UNITED STATES PATENT AND TRADEMARK OFFICE

APPLICATION NO.	FILING DATE	FIRST NAMED INVENTOR	ATTORNEY DOCKET NO.	CONFIRMATION NO.
10/698,091	10/31/2003	William J. Worrell JR.	20020391.ORI	9704
23595	7590	06/02/2006	EXAMINER	
NIKOLAI & MERSEREAU, P.A. 900 SECOND AVENUE SOUTH SUITE 820 MINNEAPOLIS, MN 55402			CHAMBERS, TROY	
			ART UNIT	PAPER NUMBER
			3641

DETAILED ACTION

Fig. 2

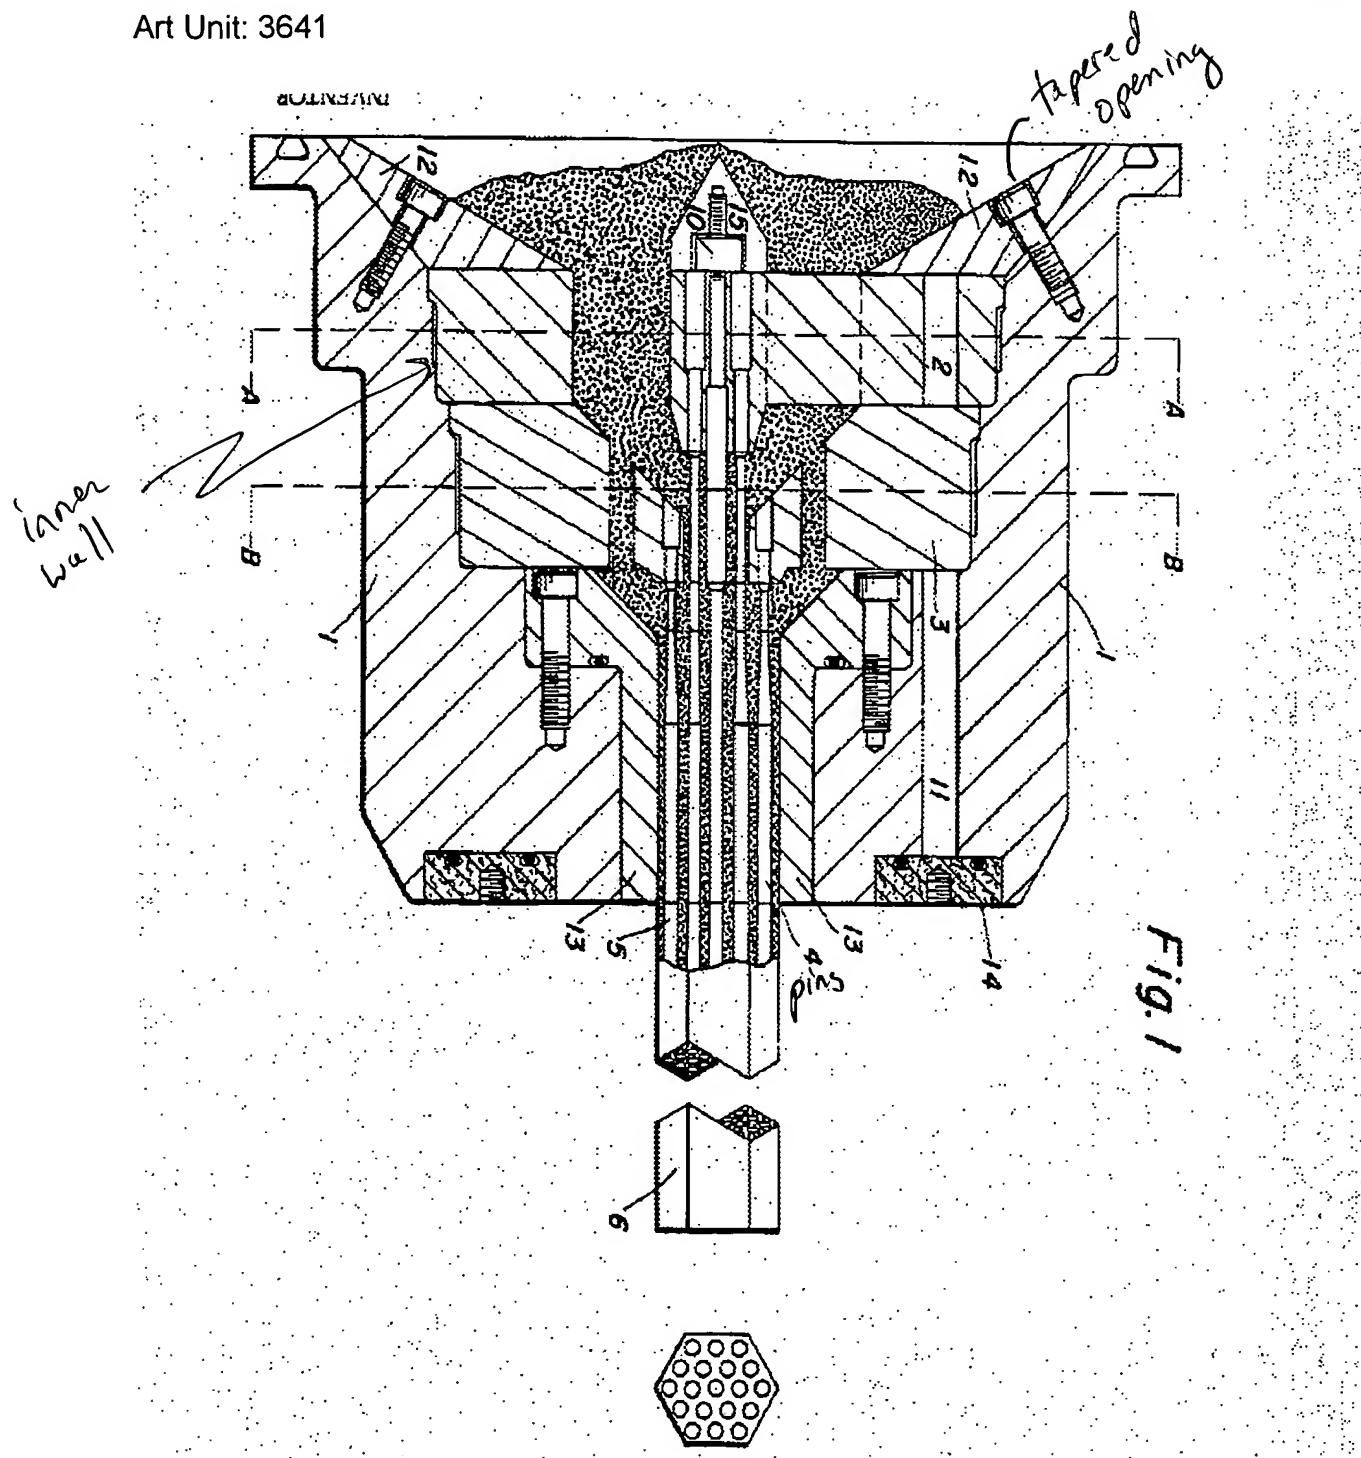
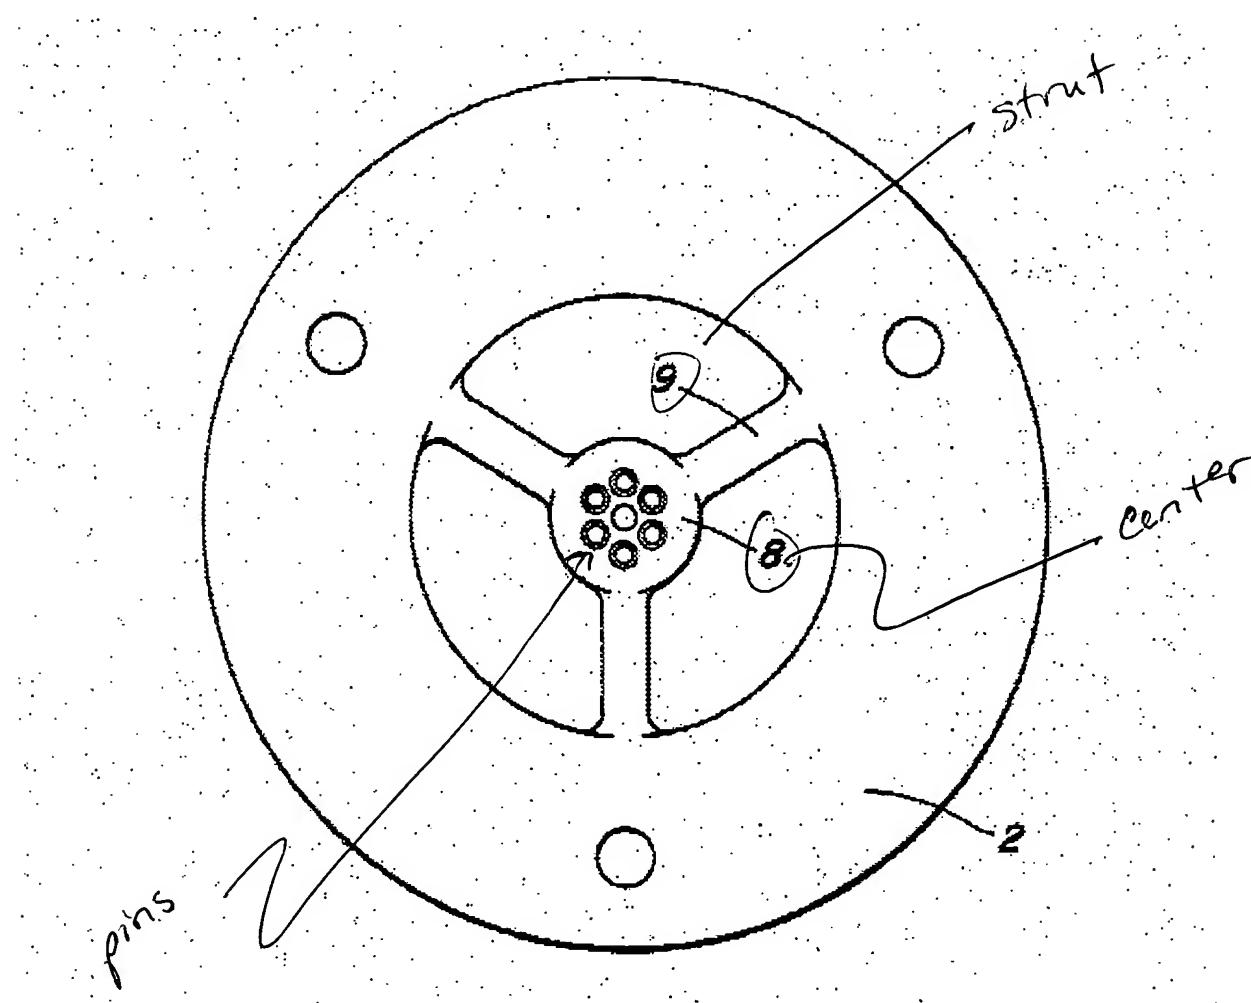
2. Claims 1-7 and 13-15 are rejected under 35 U.S.C. 102(b) as being clearly anticipated by US 3778217 issued to Bustamante et al.

4. Claim 10 is rejected under 35 U.S.C. 103(a) as being unpatentable over Bustamante. Bustamente discloses an extrusion die as shown above. However, Bustamente does not disclose a pin shape that is non-round. At the time of the invention, it would have been obvious to one having ordinary skill in the art to make the pins of Bustamente to be non-round since it has been held that such changes are a matter of design choice. In re Dailey, 357 F.2d 669, 149 USPQ 47 (CCPA 1966) (The court held that the configuration of the claimed disposable plastic nursing container was a matter of choice which a person of ordinary skill in the art would have found obvious absent persuasive evidence that the particular configuration of the claimed container was significant.) Moreover, the applicant's specification did not mention that such a shape is critical to the operation of the invention.
